**CITY OF EL PASO, TEXAS
AGENDA ITEM
DEPARTMENT HEAD'S SUMMARY FORM**

Contract Change Order Coversheet /Checklist City of El Paso Capital Improvements Department

CITY OF EL PASO CONSTRUCTION CHANGE ORDER

RFI #110: Electrical Services Issue

**GERONIMO - STATION 3
ELECTRICAL SITE
PLAN**

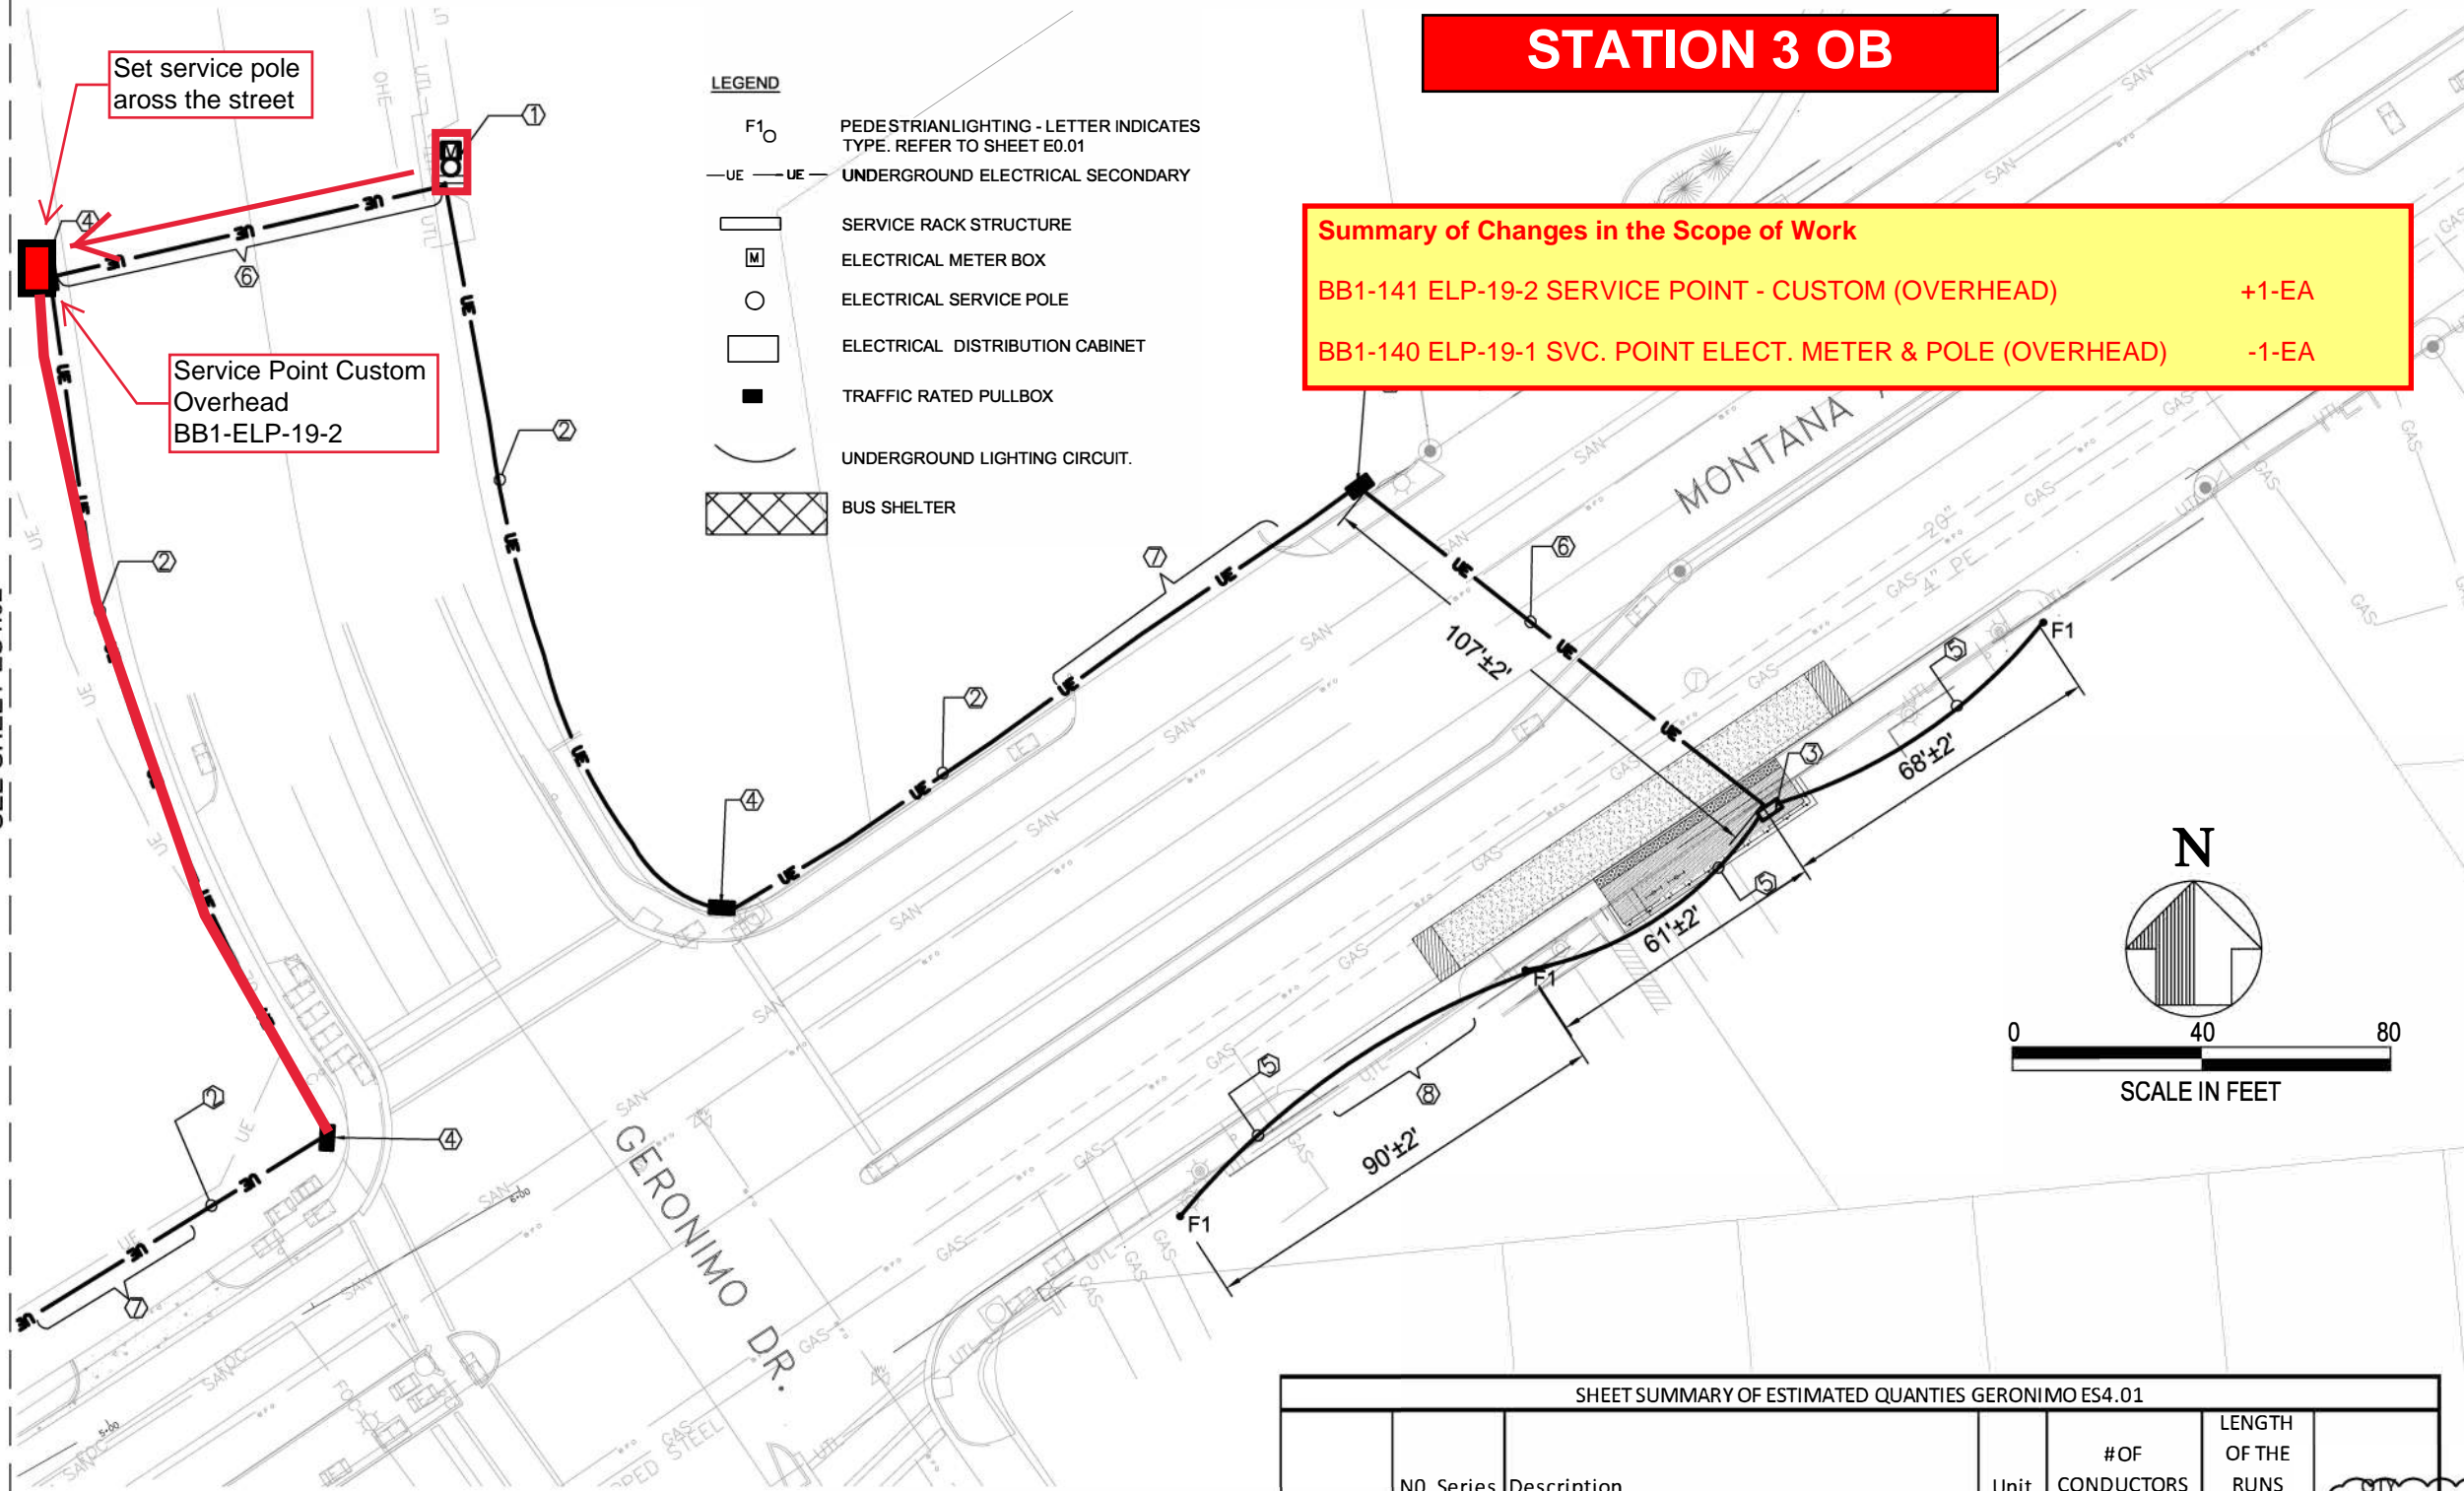
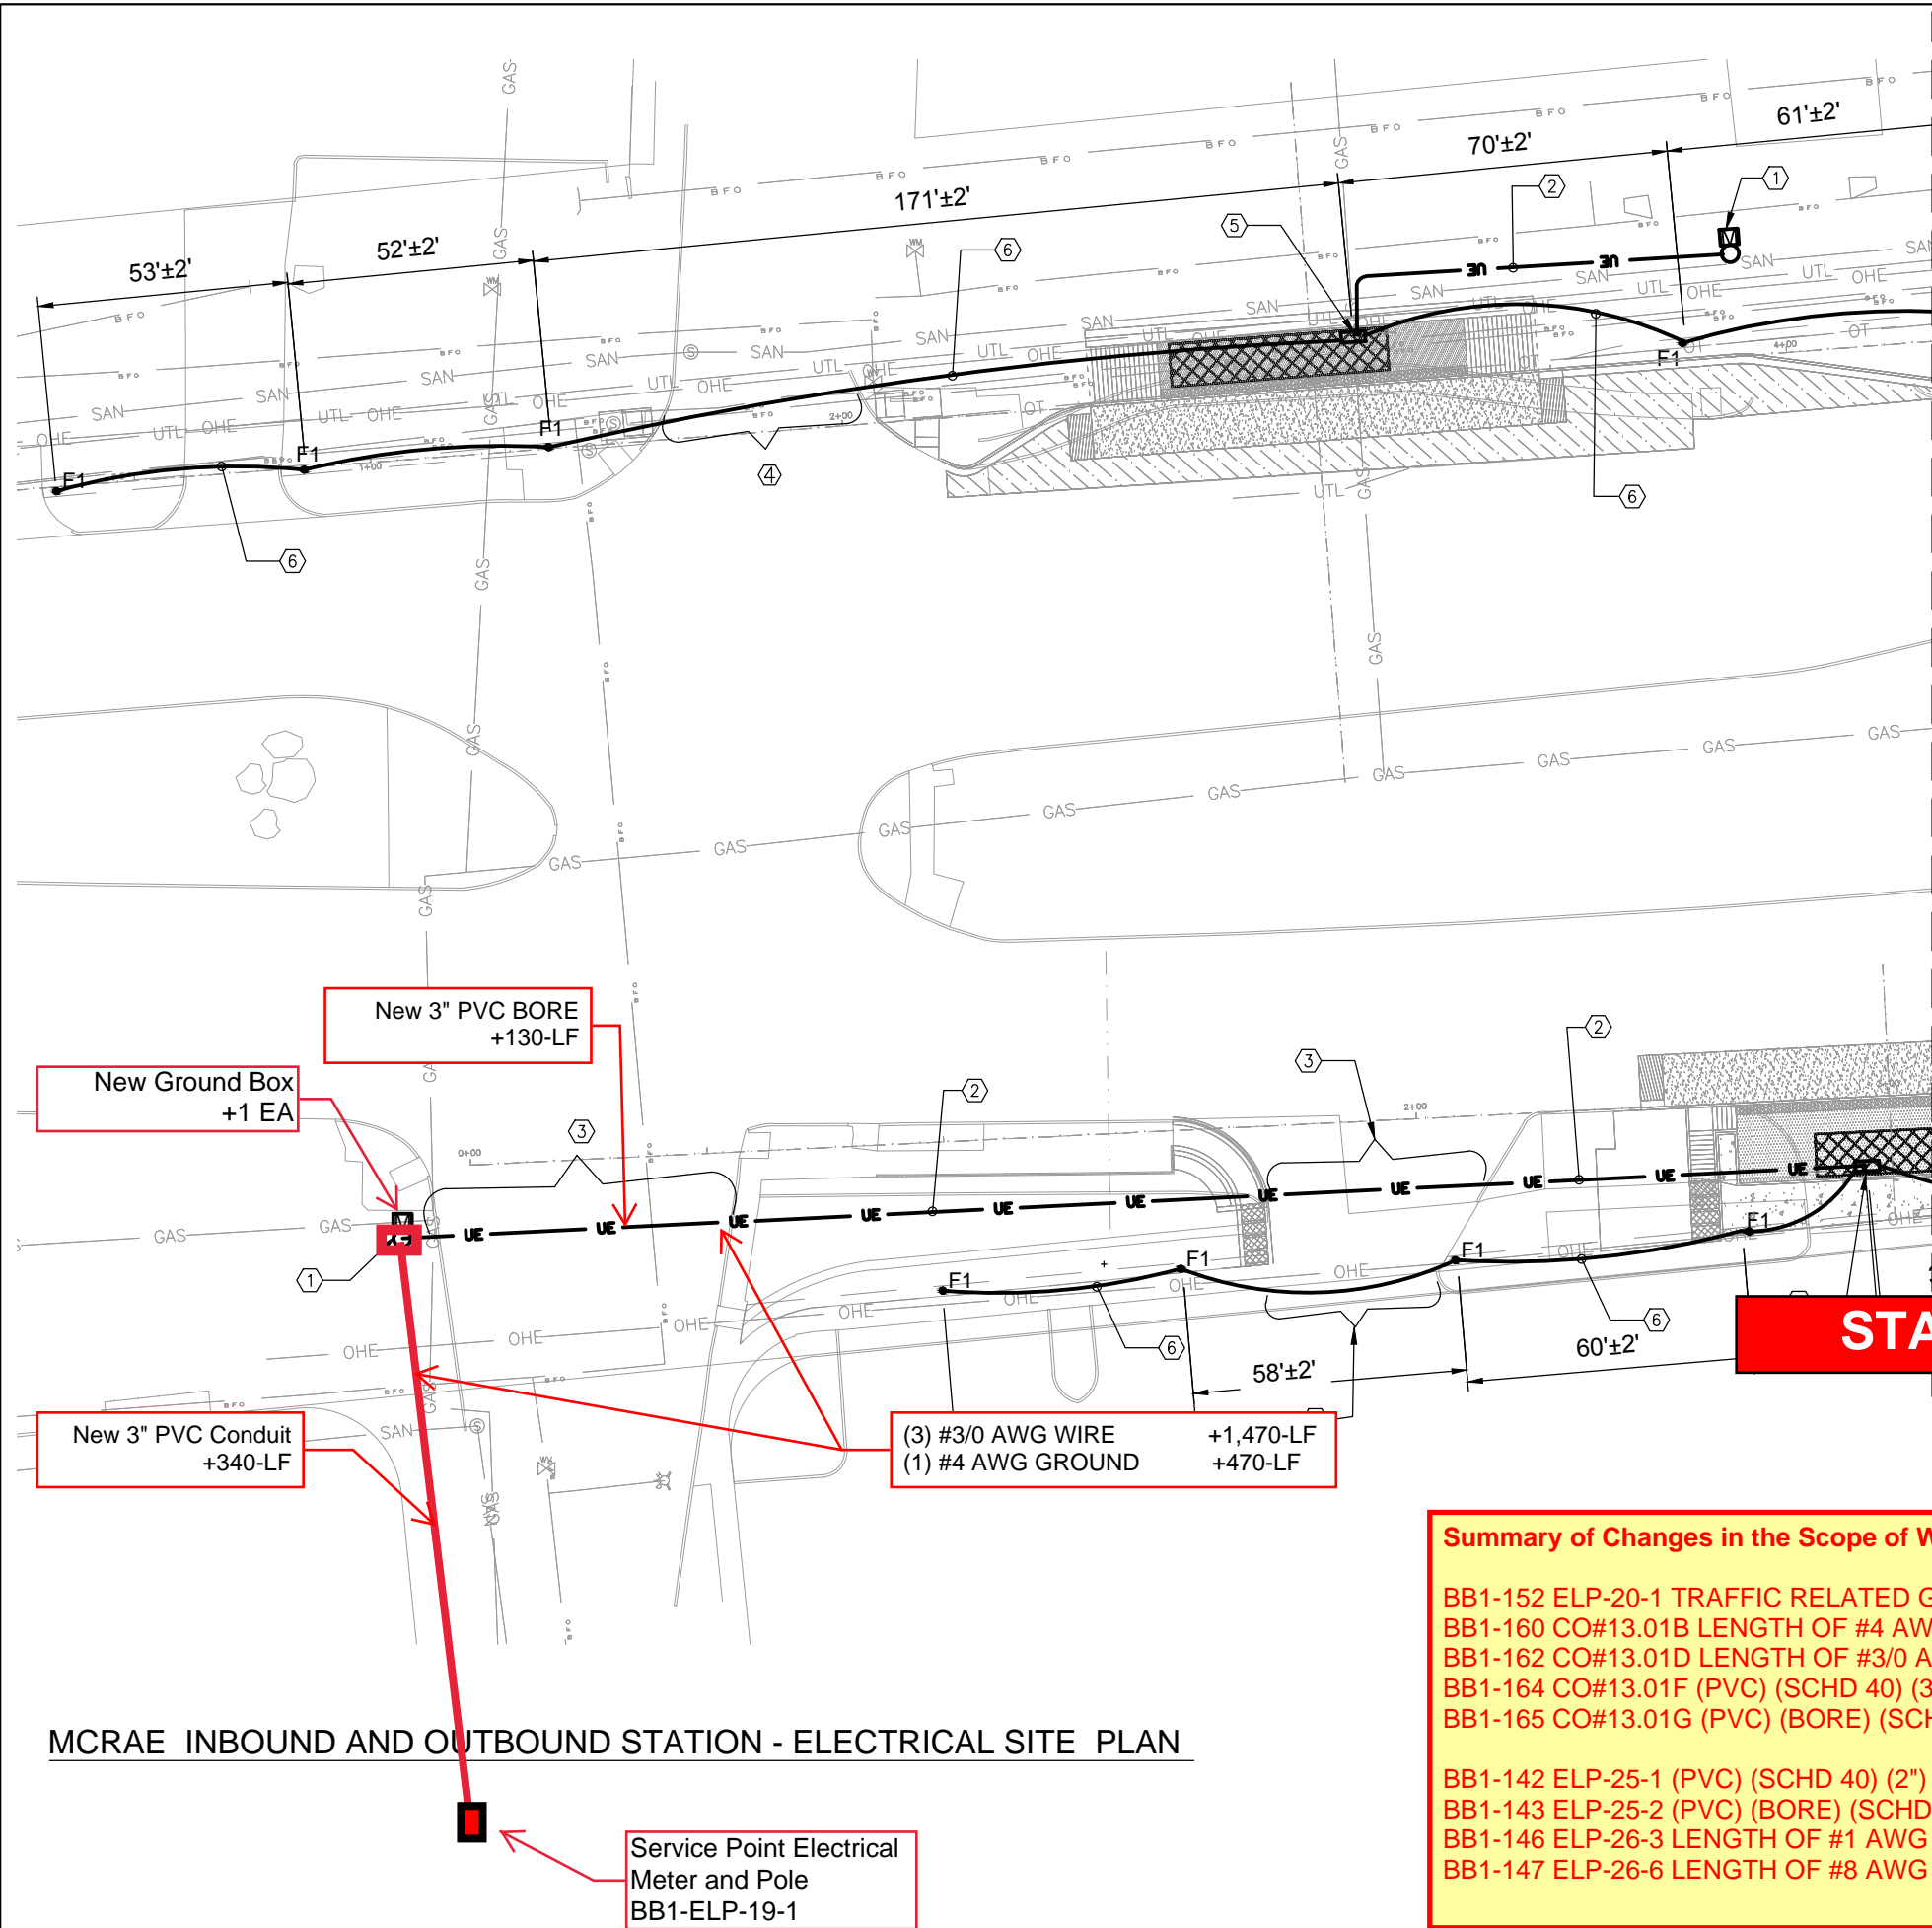
- ① PROVIDE ELECTRICAL SERVICE AS INDICATED ON DETAIL 2 SHEET E0.02
- ② PROVIDE (1) 3" C PVC SCHEDULE 40. WITH (3)#3/0 AWG AND (1)#4 GND FROM THE ELECTRICAL METER TO BUS STATION AS INDICATED.
- ③ TERMINATE ELECTRICAL FEEDERS IN 100A MAIN BREAKER PANEL INSIDE ELECTRICAL CABINET. REFER TO SHEET E0.03 FOR MORE INFORMATION.
- ④ PROVIDE 24"x12x12" QUAZITE PC STYLE POLYMER CONCRETE ASSEMBLY TRAFFIC RATED PULLBOX

⑥ JACK/BORE AND PROVIDE (1) 3" C PVC SCHEDULE 40 WITH (3)#3/0 AWG, (1)#4 GND COORDINATE WITH TXDOT.

⑦ JACK/BORE AND PROVIDE (1) 3" C PVC SCHEDULE 40 WITH (3)#3/0 AWG, (1)#4 GND.

| MONTANA RAPID TRANSIT SYSTEM LORNE - STATION 9 ELECTRICAL SITE PLAN | | | | |

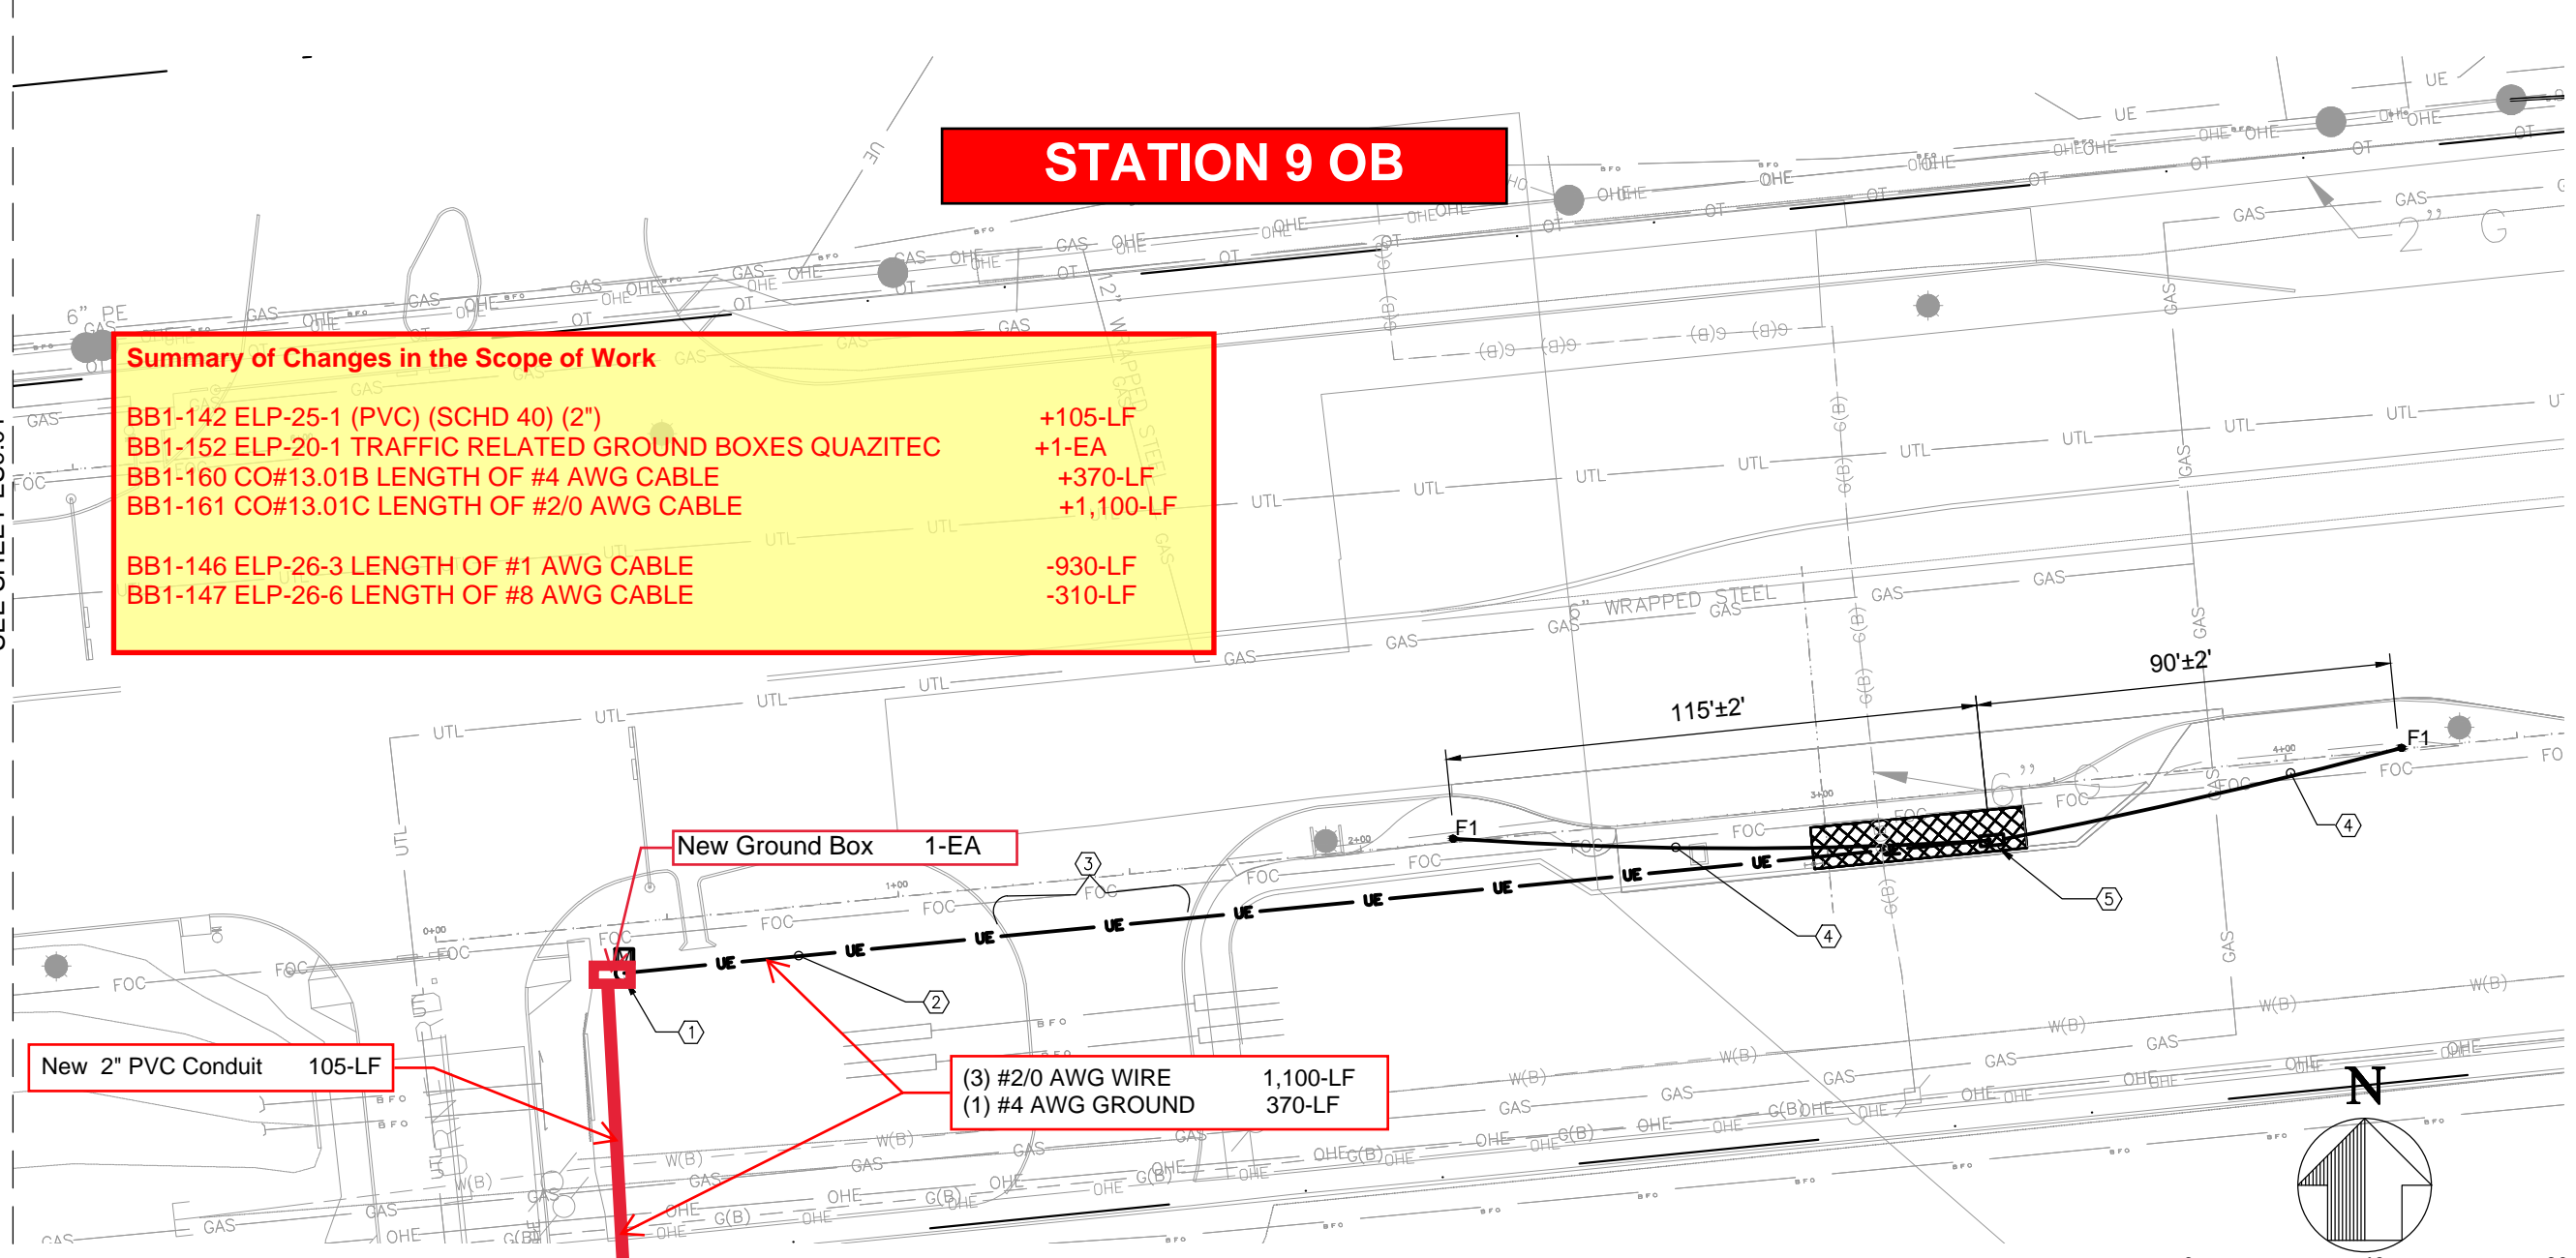
| BB1-146 ELP-26-3 LENGTH OF #1 AWG CABLE | -930-LF |
| BB1-147 ELP-26-6 LENGTH OF #8 AWG CABLE | -310-LF |
